Re: ERN-7 Comment

- On the west side of Laurel Crossing along Hill Road, please update the easement to be a 20' Drainage & Utility Easement.

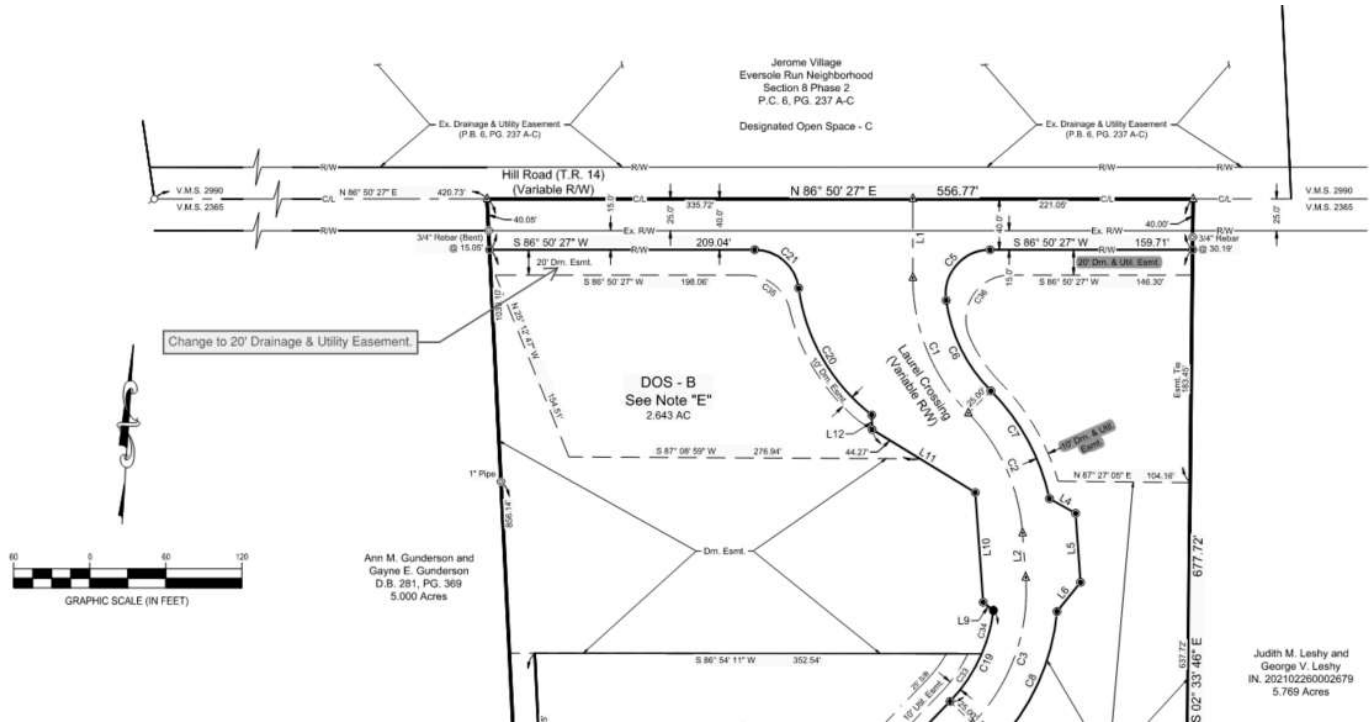
Below is an image showing our comment regarding the easement along Hill Road. We simply need to change it to a Drainage & Utility Easement.

Would you please confirm whether this request is limited to the easement area long Laurel Crossing or also along Hill Road—i.e. along one of the roads or both of the roads.
